Sandon Point Flood Study

Addendum No. 1

106062-03 Report 002 rev 2

Prepared for Stockland Development Pty Ltd

Figure 2 Comparison of Bridge Modelling Techniques for Hewitts Creek

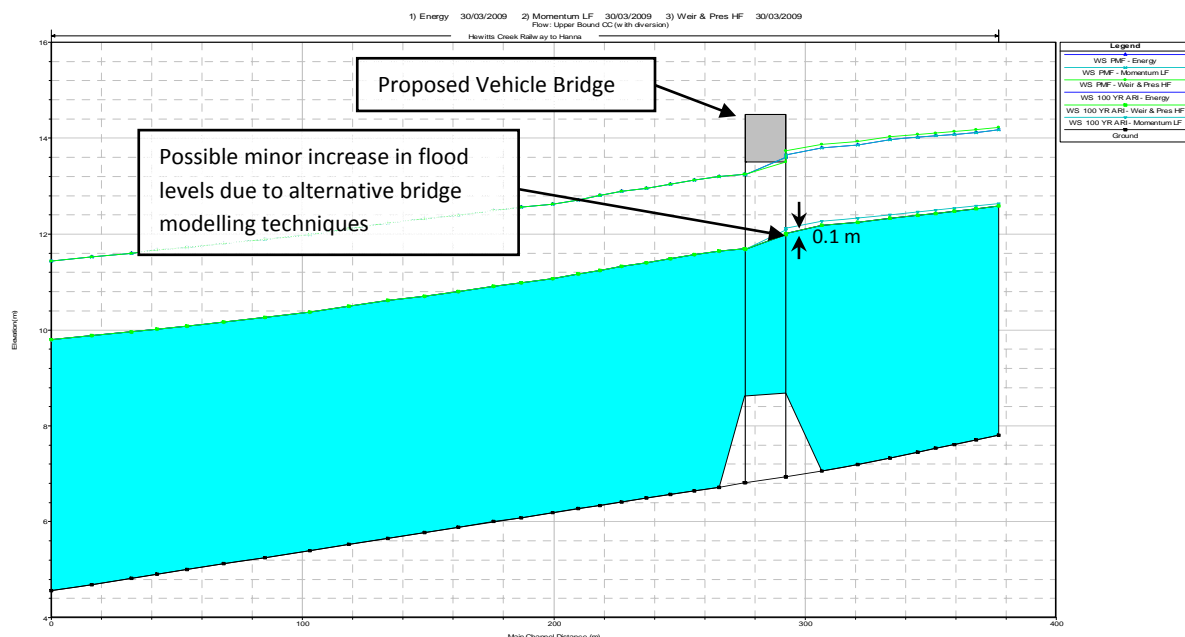
Undertake further flood modelling, utilizing the appropriate bridge modelling approaches for the proposed bridges on Woodlands and Hewitts Creeks, and subsequently provide the flood modelling results to demonstrate the sensitivity of the design flood levels to the change in bridge modelling approach;

Flow through the Hewitts Creek Bridge operates under low flow conditions (i.e. channel flow) for events up to the 100 year ARI and high flow conditions for the PMF. This assessment was performed with the bridge 25% blocked and using the future upper bound climate change scenario flows. During the 100 year ARI, when using the momentum balance equation, flood levels reach a maximum of 0.10 m higher on the upstream side of the bridge. It is noted that there is no change in the 100 year ARI flood levels when using the weir plus pressurised flow for high flow conditions as the water level does not reach the underside of the bridge deck (so pressurised flow does not occur).

When using the weir plus pressurised flow for high flow conditions during the PMF, the resulting flood levels are a maximum of 0.08 m higher on the upstream side of the bridge. It is noted the momentum balance equation becomes invalid for this flow scenario as water touches the underside of the bridge.

We confirm that using alternative bridge modelling techniques does not adversely affect flood levels in Hewitts Creek. The minor increase in flood levels just upstream of the proposed vehicle bridge

during the 100 year ARI (a maximum of 0.1 m) is within the 0.5 m of freeboard incorporated into the development (above the 100 year ARI flood level) to cater for modelling uncertainties. Floor levels for all proposed dwellings should therefore be based on flood levels presented in the March 2008 Sandon Point Flood Study.

Figure 6 Conservative Climate Change Beach Berm Effects

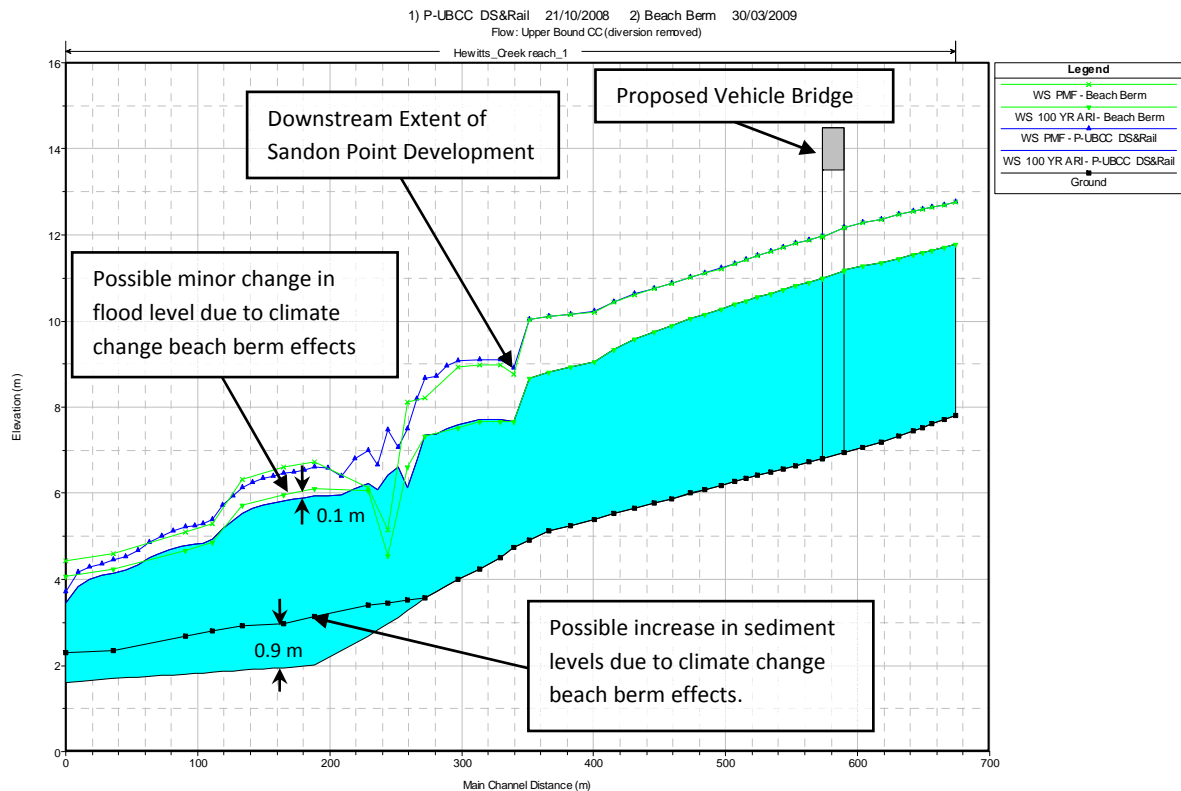
Consider the impact of climate change-induced beach berm migration (associated with sea level rise and shoreline recession) on flooding behaviour in Woodlands and Hewitts Creeks

As recognised by SKM it is difficult to quantify effects of the inland shift of the beach berm shift and the coastal lagoon. We have formulated a conservative approach to assess any effects on flood levels that the beach berm recession may have even though the berm would likely be scoured out during a flooding event. To assess the effects of an increase in beach berm height we have performed a sensitivity analysis on the effects of increasing the downstream base levels of Hewitts Creek.

Conservatively adding the suggested 0.9 m to sediment levels and matching the bed slope profile to extend to the raised (or filled in areas) in the model cross sections results in a very minor effect on upstream flood levels. This is illustrated in **Figure 6** below which shows the 100 year and PMF flood levels for upper bound climate change scenario with a high range sea level rise.

The upper and the lower green lines denote the water surface levels at the peak of the PMF and 100 year ARI respectively for the possible upper bound climate change scenario with a raised beach berm. The upper and lower blue lines denote the water surface levels at the peak of the PMF and 100 year ARI respectively for the upper bound climate change scenario presented the March 2008 Flood Study .

Based on this conservative approach, there would be no impact on the Sandon Point development due to beach berm recession along Hewitts Creek.

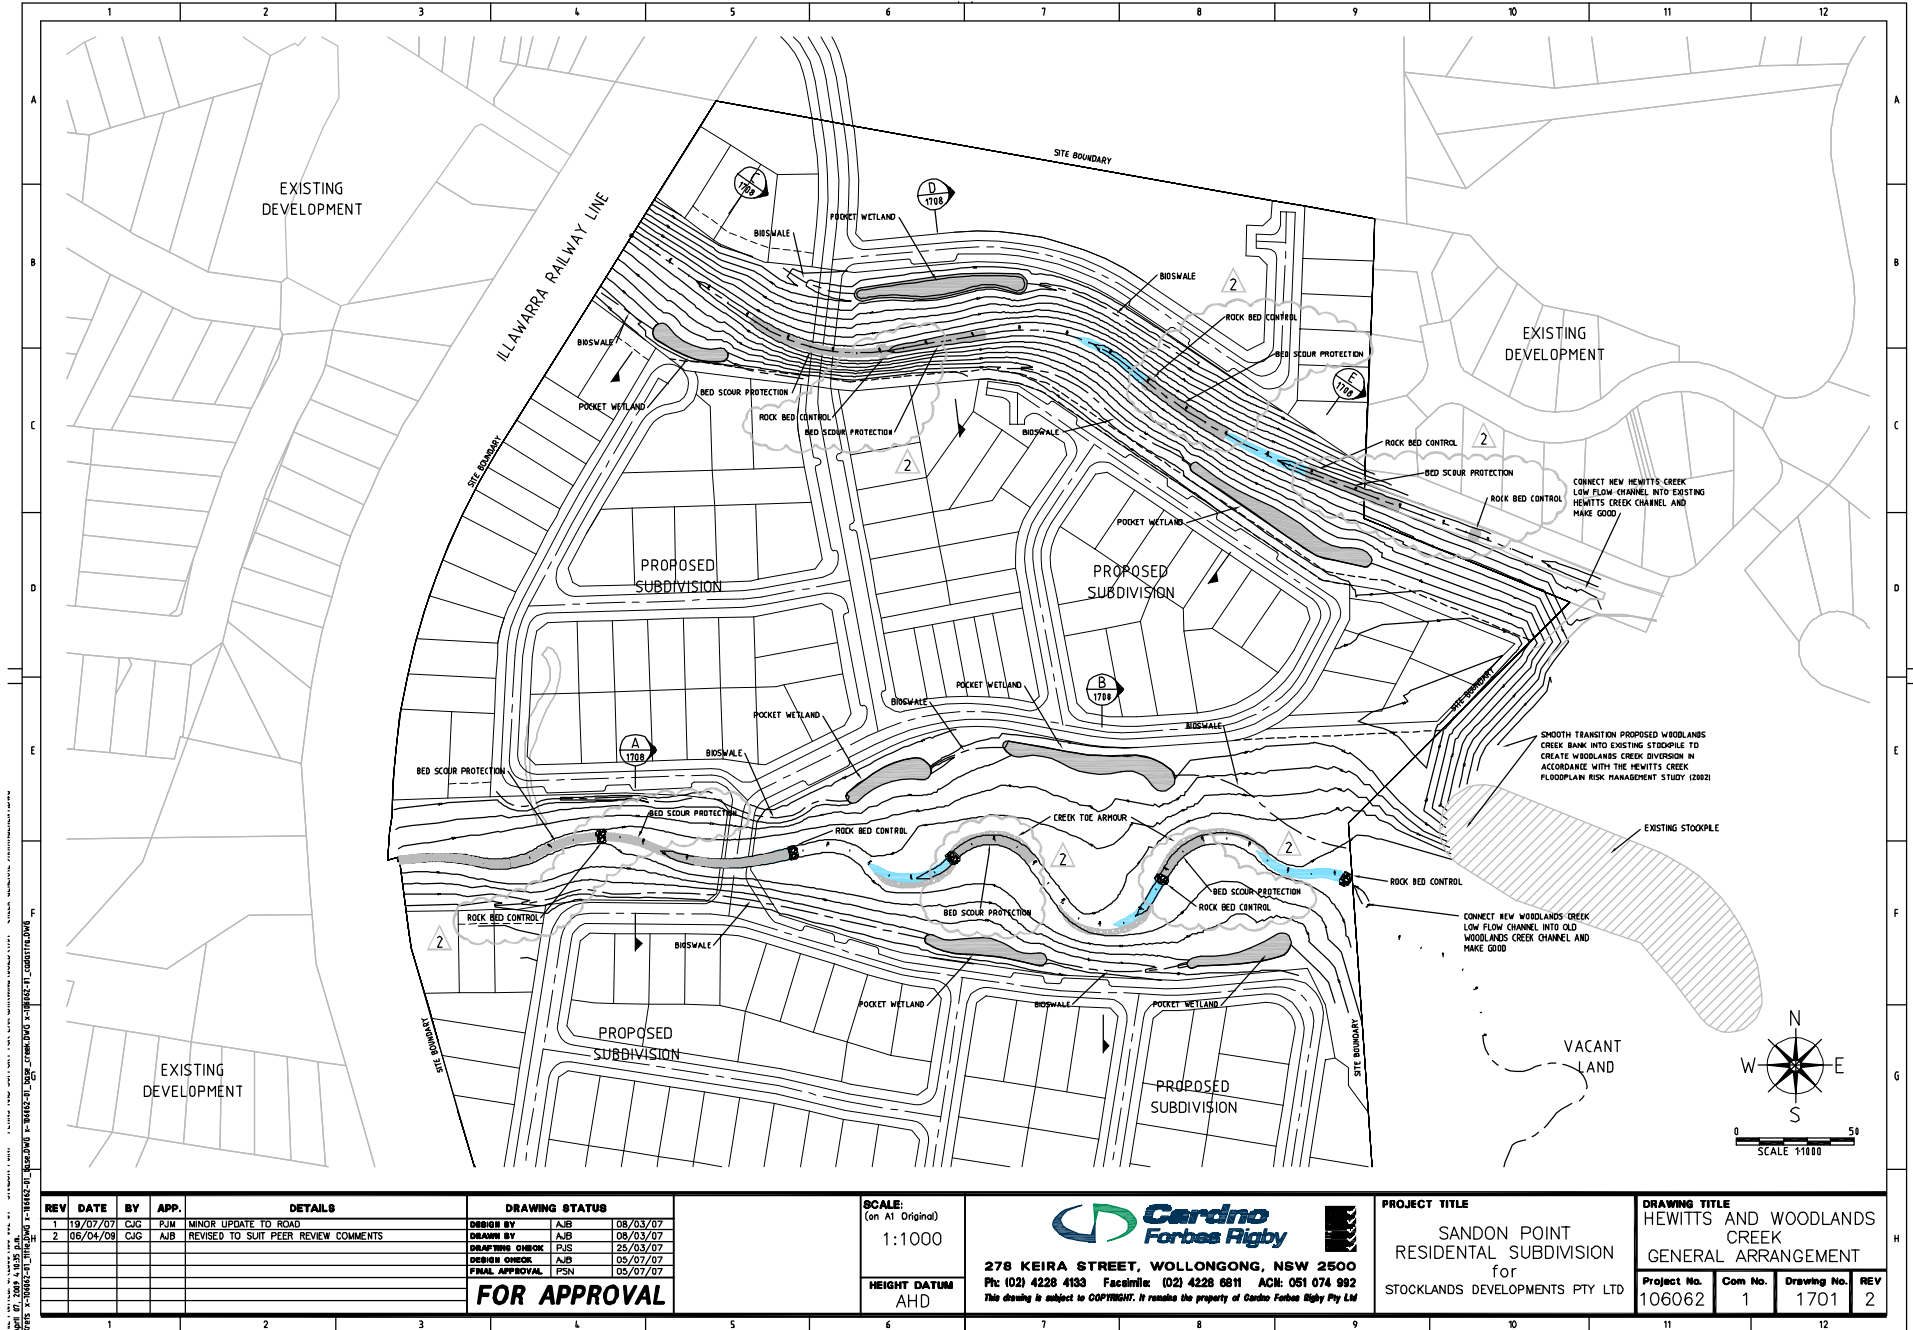
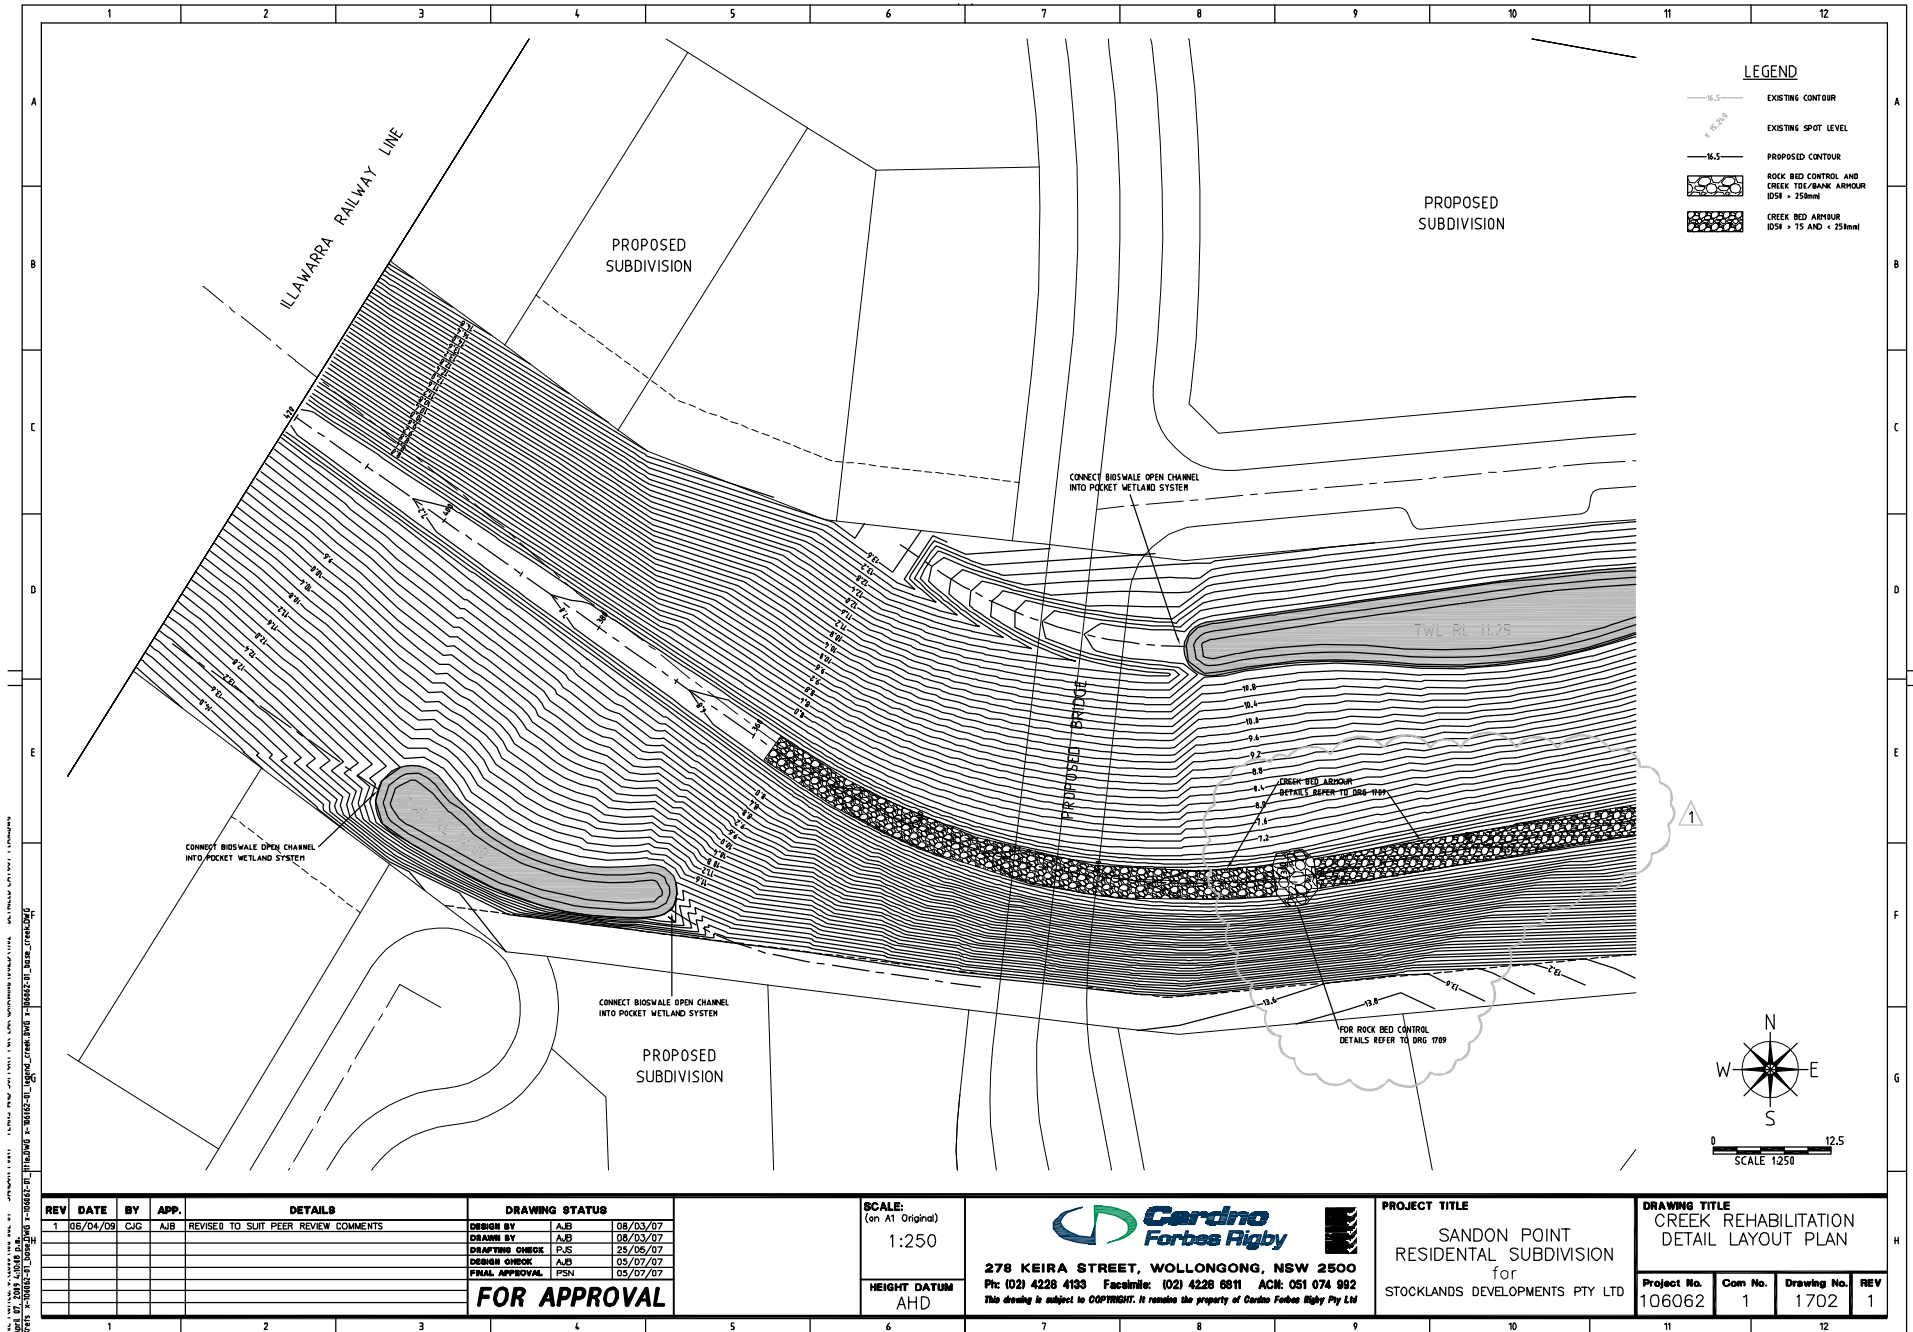
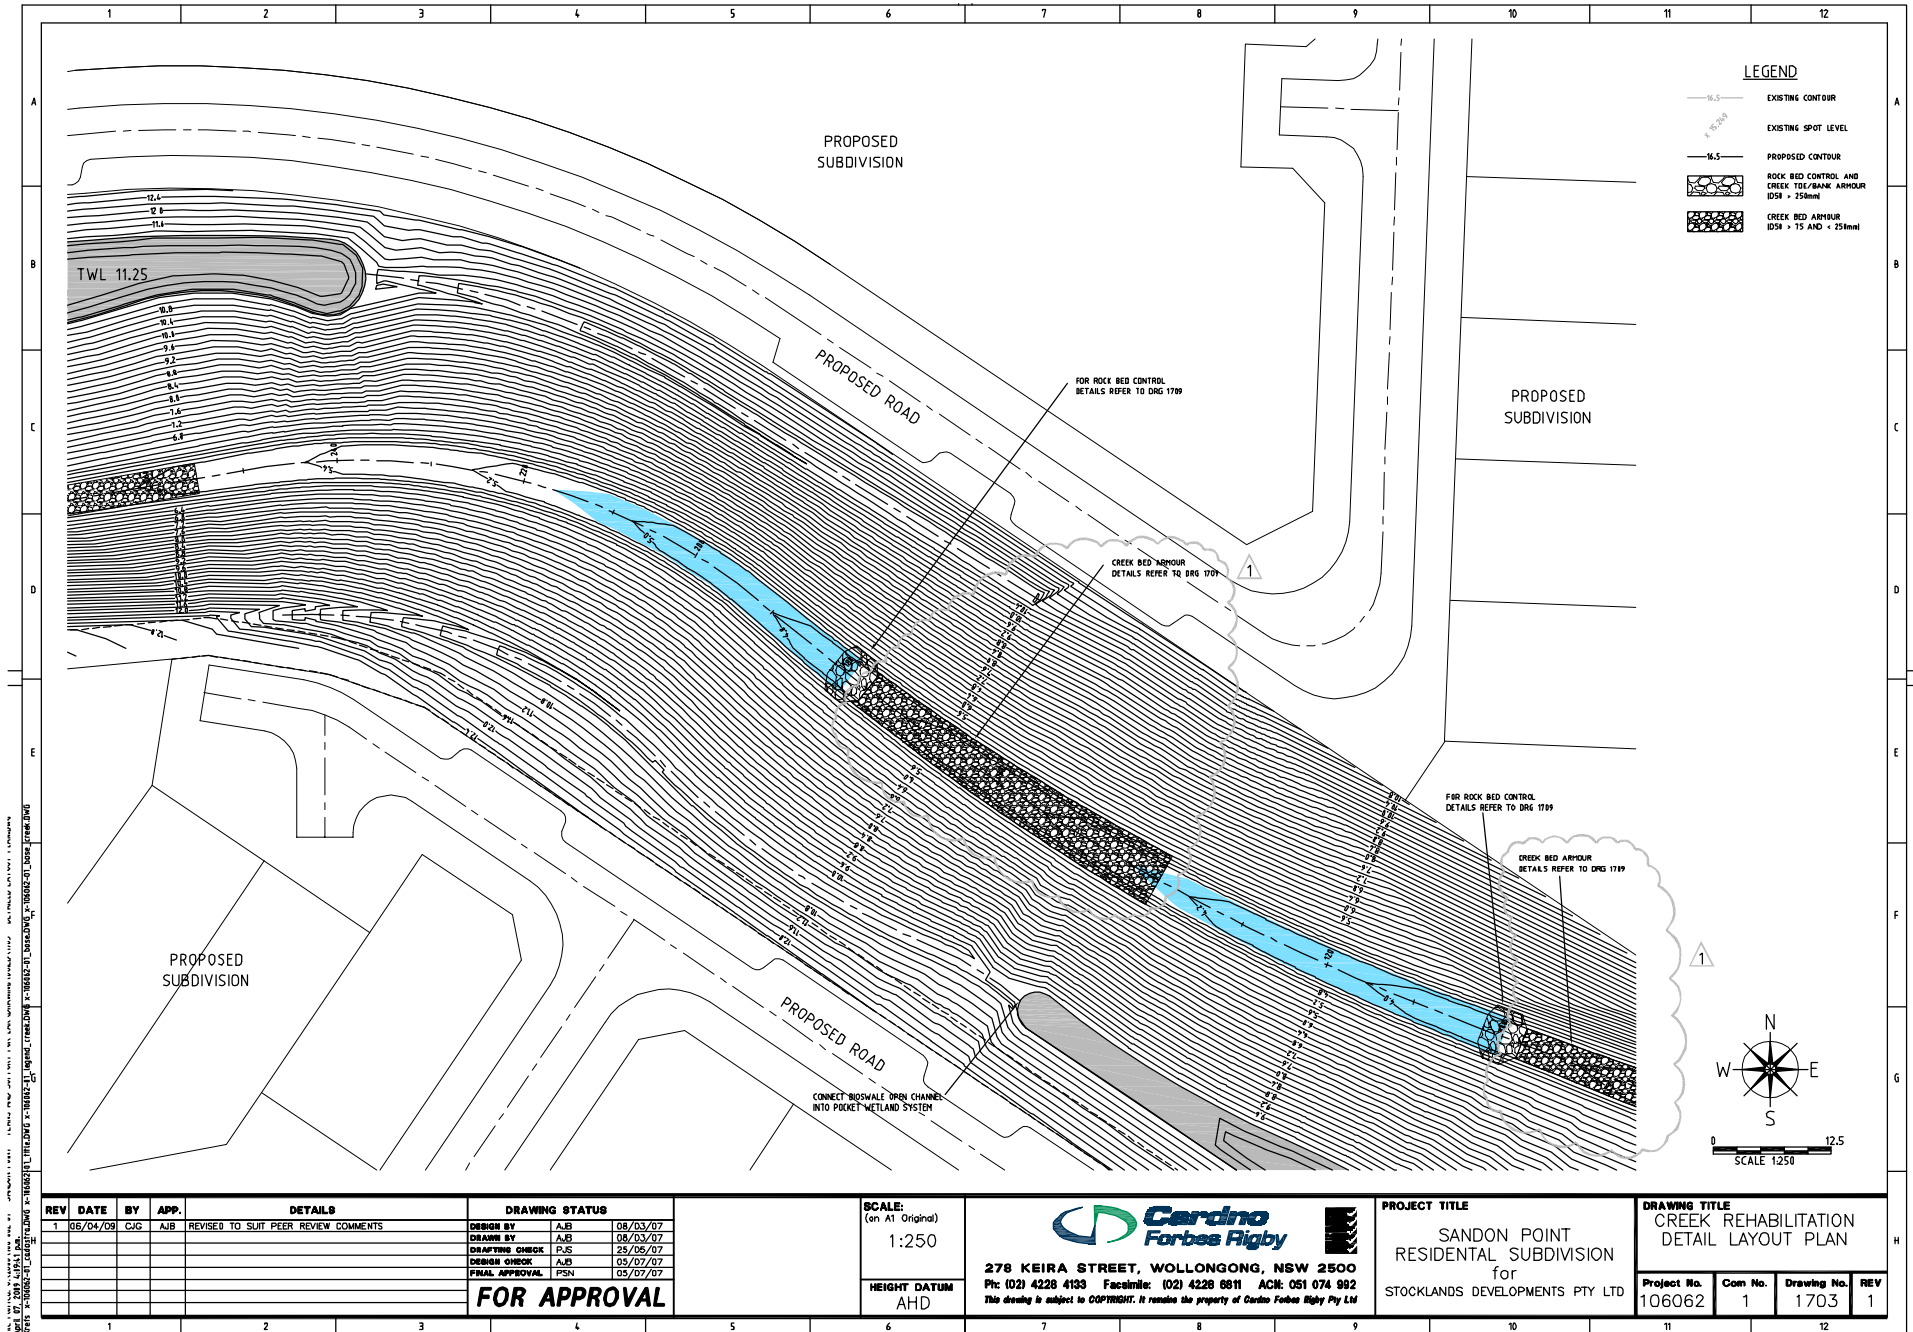
Sizing of rocks in the erosion protection treatments is potentially undersized, considering the estimated shear stresses and velocities, and the shear stress and velocity thresholds presented in Fischenich (2001), on which Cardno's rock armour sizing is based. While the general nature of the treatments are acceptable, the size of the rocks which make up the treatment may need to be increased to provide sufficient stability (given the Director-General's requirements for a 20 year ARI design event). Therefore, it is recommended that Cardno reconsider the required sizing of the rocks in the erosion protection treatments.

CFR has amended the design plans to show a general increase in the application of rock to the creek bed, to cater for SKM's concerns regarding a potential under sizing of this material. The updated design plans are included in this report as **Appendix B**. CFR will further consider such changes to the rock armouring details at detailed design stage. We consider no further action is required.
